DEVIATION REQUEST AND DECISION FORM

Project Name : Sterling Ranch Sand Creek Channel Construction Drawing Review CDR 20-4
 Schedule No.(s) : 5227301021, 5233309027, 5228000030 & 38, 5233301001 5233301016 & 17
 Legal Description : See Exhibit B – Legal Description

A deviation from the standards of or in Section **ECM section 3.3.3 Open Channel Design Standards** of the Engineering Criteria Manual (ECM) is requested for the Sand Creek Channel Design – Low Flow Channel Capacity.

Exhibit A

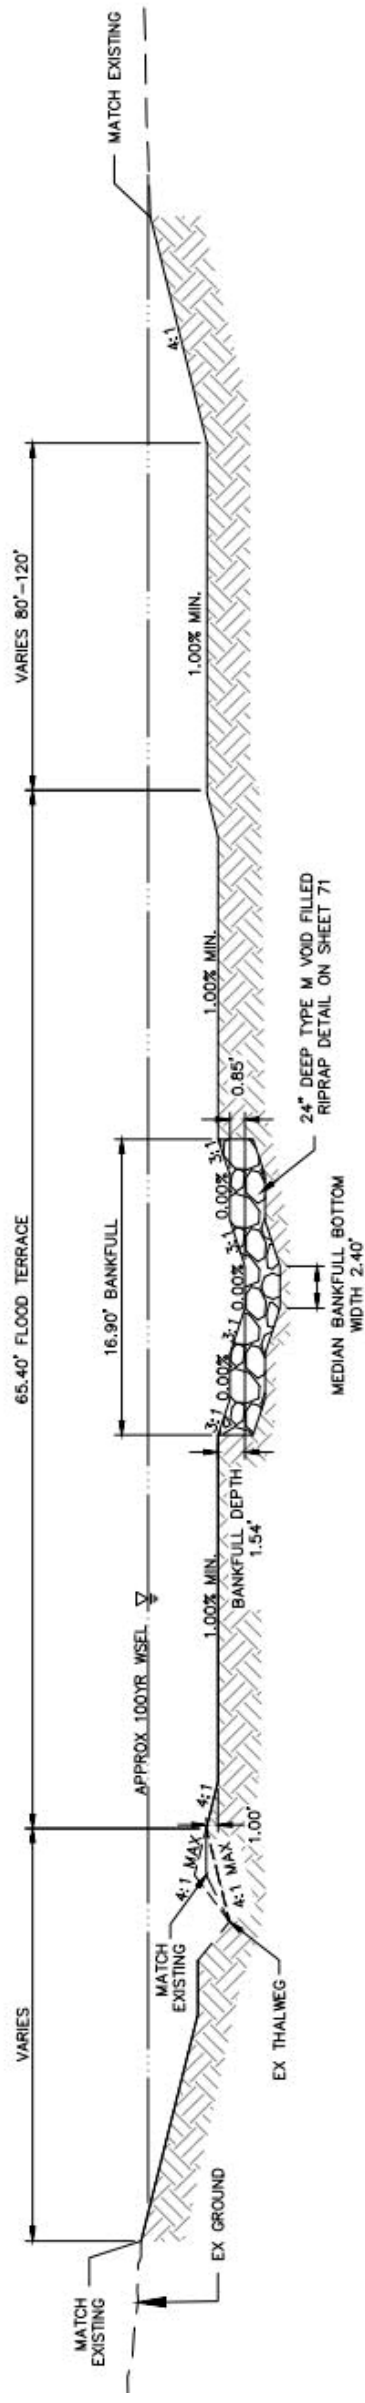
See Exhibit A for a representation of the “geomorphologist recommended” low flow channel cross section.

The proposed low flow channel in the Sterling Ranch Sand Creek design is approximately 16.9 feet wide and 1.54 feet deep and has a capacity of 29 cubic feet per second. The low flow channel is armored with 24” deep type M void filled rip rap.

The geomorphologist's reasoning for the smaller low flow channel cross section was that base flows in this reach of the channel are a fraction of the ECM criteria. Base flows in this portion of Sand Creek are a fraction of the required low flow capacity and the required low flow channel would be far larger than necessary to deal with the base flows, eventually leading the channel to cut its own low flow section for base flows. By using a narrower multi-stage section within the bankfull, dense vegetation can establish itself, particularly along the inner berm. Instead of the bankfull being sized for the larger events, the flood terrace has been sized to convey the two year storm. The frequency that the flood terrace sees inundation will also allow for denser vegetation within the flood terrace extents. Since the bankfull will be carrying a smaller proportion of the larger events, the floodplain is wide enough to ensure that flow depth remains low outside of the flood terrace. Shear stresses in the overbanks are low enough that seeding and riparian plantings will be sufficient to withstand the high flow events, with only a few areas requiring more substantial treatment.

This request is not based on financial considerations. The primary reason for the reduced size low flow channel is keep base flows contained and allow for a wide shallow flood terrace to promote dense wetland vegetation growth.

By using the recommended widths of the geomorphology study, a more stable channel thalweg is achieved which is more consistent with what has naturally occurred. Maintenance requirements should be minimal.

Maintenance of the low-flow channel shall be by the Sterling Ranch Metro District.

Full stabilization and vegetation density will be required prior to preliminary acceptance
